Fox Professional Geology, PLLC
310 Cherry Road
Syracuse, New York 13219

19 February 2024

RE: Document Review
Brillo Landfill Site
Town of Victory, Cayuga County, New York
FoxPG Project Number STE-002

Figure 10 – 2021 RI Conceptual Site Model for Former Drum Storage Area
Source: Figure 16C from TRC (2021)

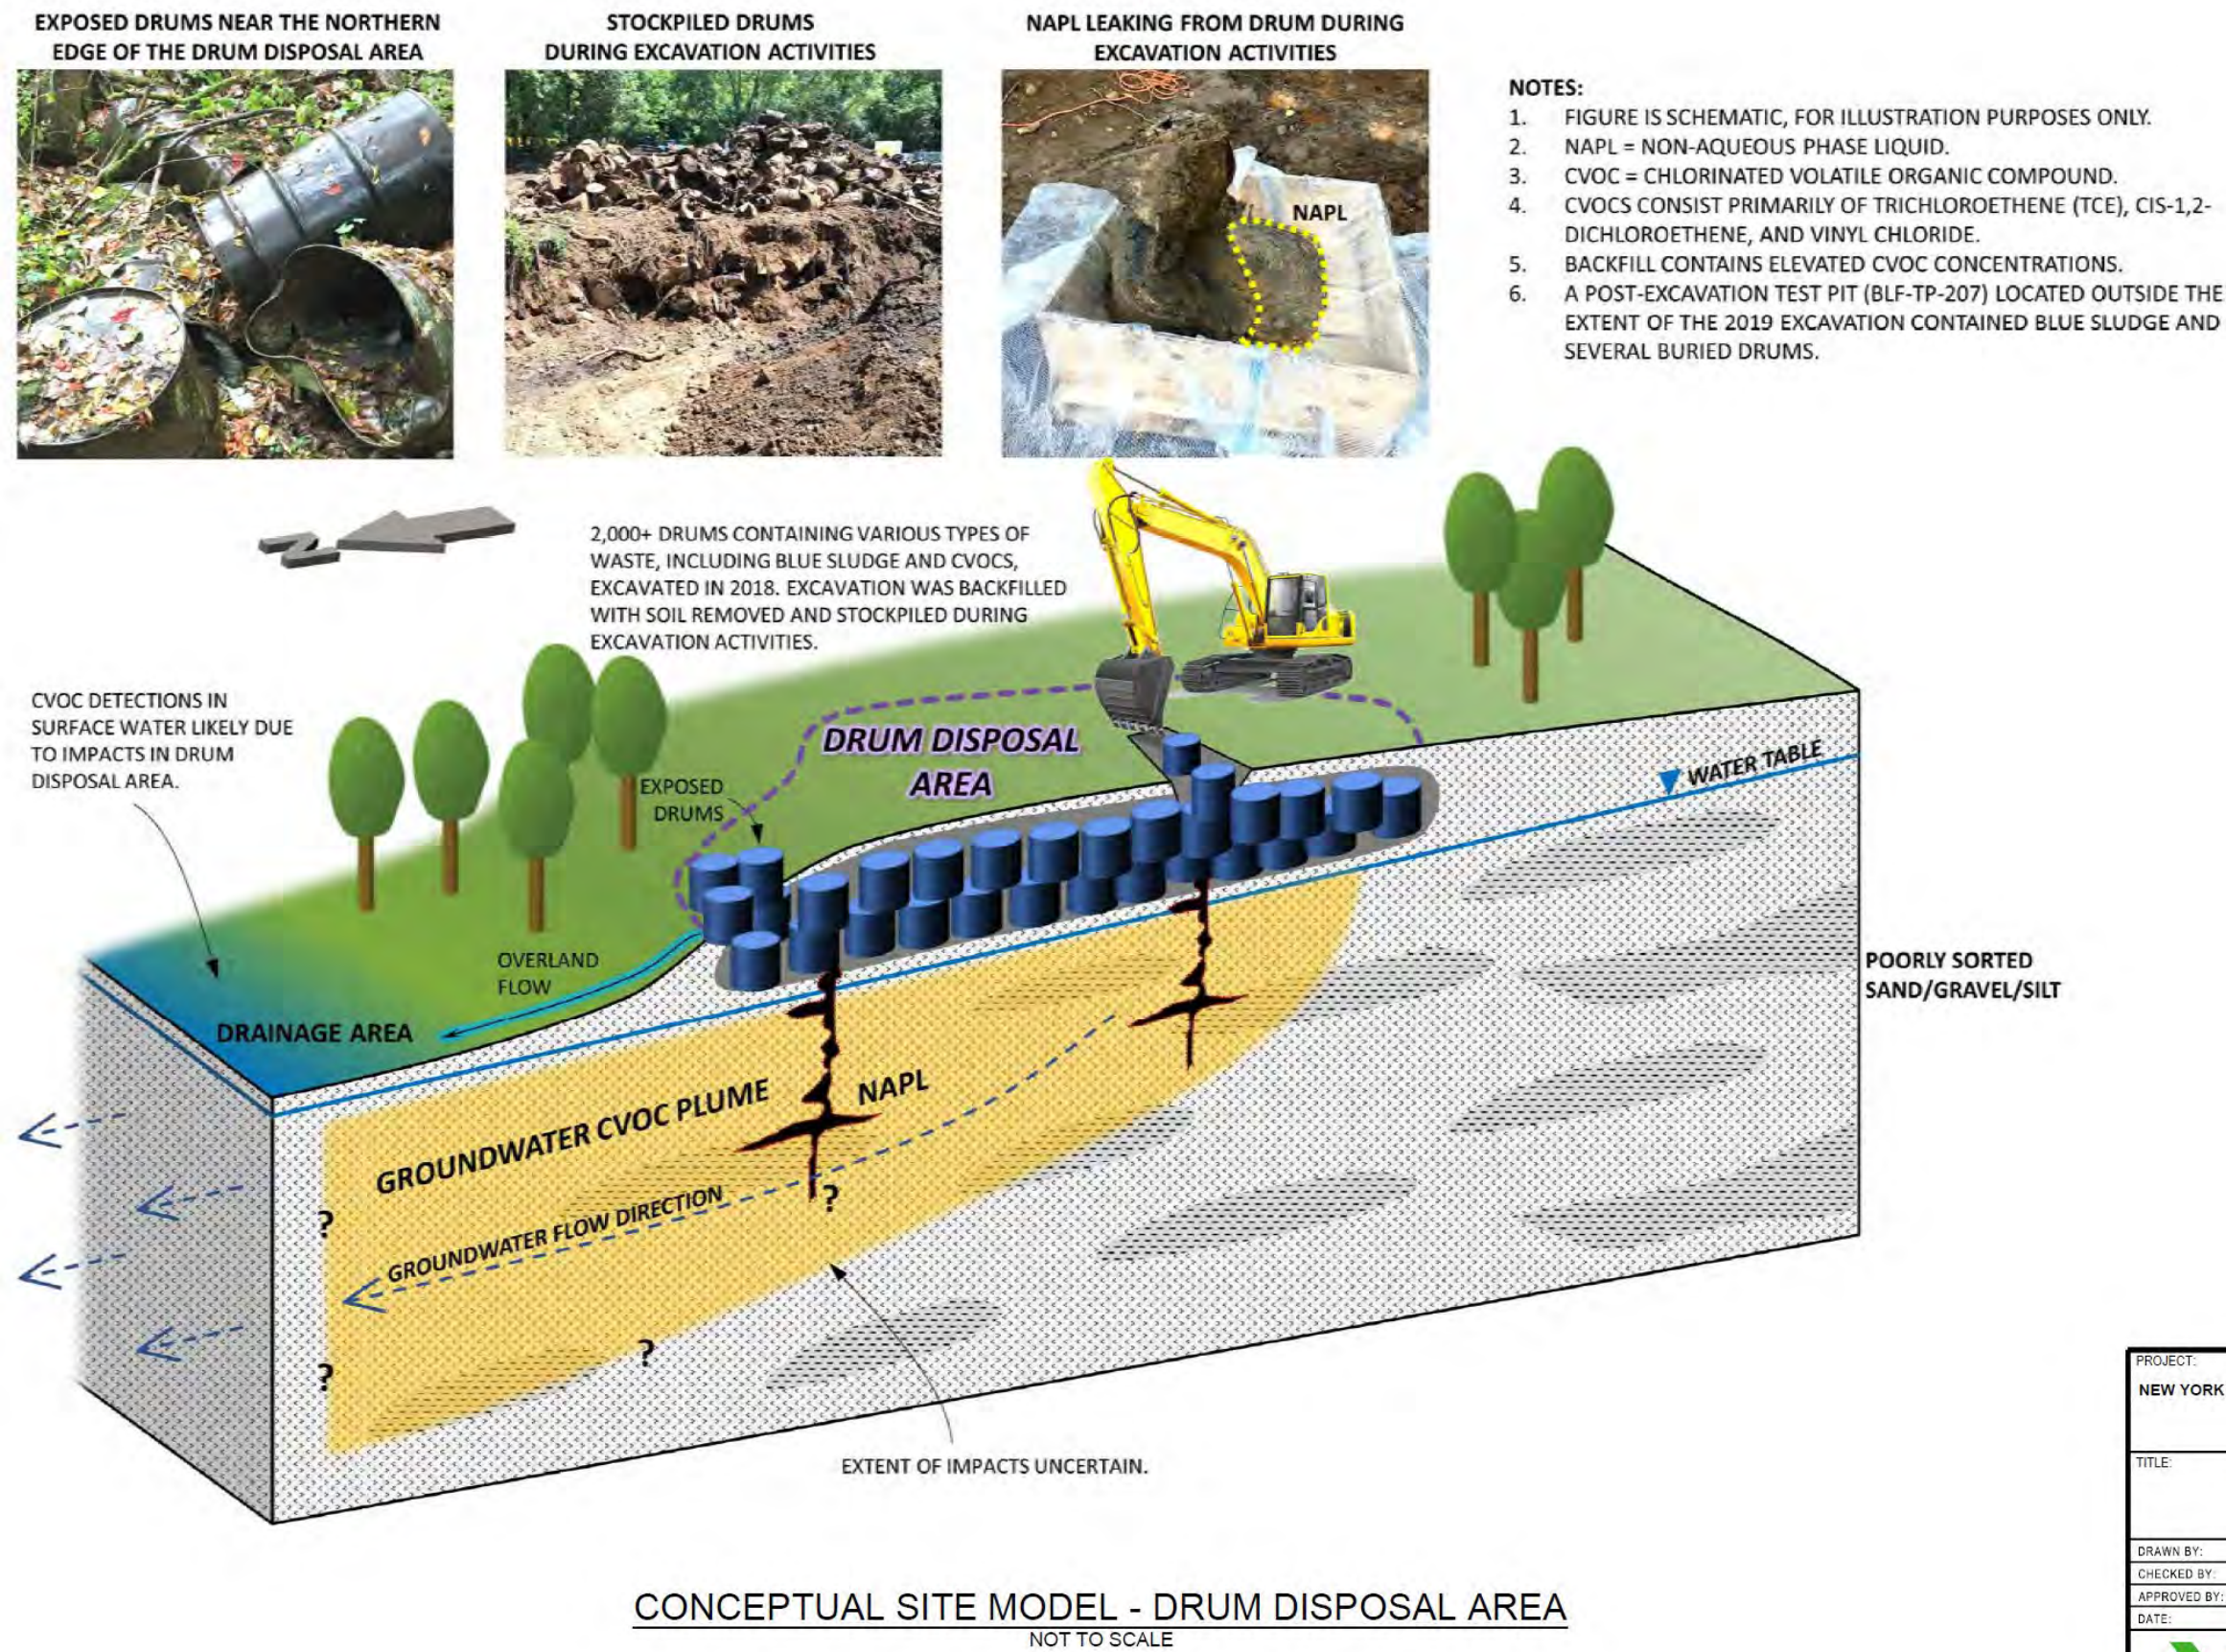
- Figure 10 (Attachment A) shows a CSM from the RI Report for the Former Drum Storage Area. This CSM shows the presence of NAPL (likely including DNAPL) in the subsurface, which constitutes a source area which must be addressed. Question marks included in this CSM indicate that the extent of NAPL has not been determined. The primary goal of a RI is to fully evaluate the lateral and vertical extent of contamination at a Site; therefore, the RI of this Site has not been completed. This CSM also shows a groundwater CVOC plume. Question marks in the CSM along and the statement “EXTENT OF IMPACTS UNCERTAIN” indicate that the lateral and vertical extents of the CVOC plume are currently unknown.

Therefore, additional environmental investigation is required to meet the goals of a RI as described in Section 3.1(c) of DER-10 (NYSDEC, 2010a).
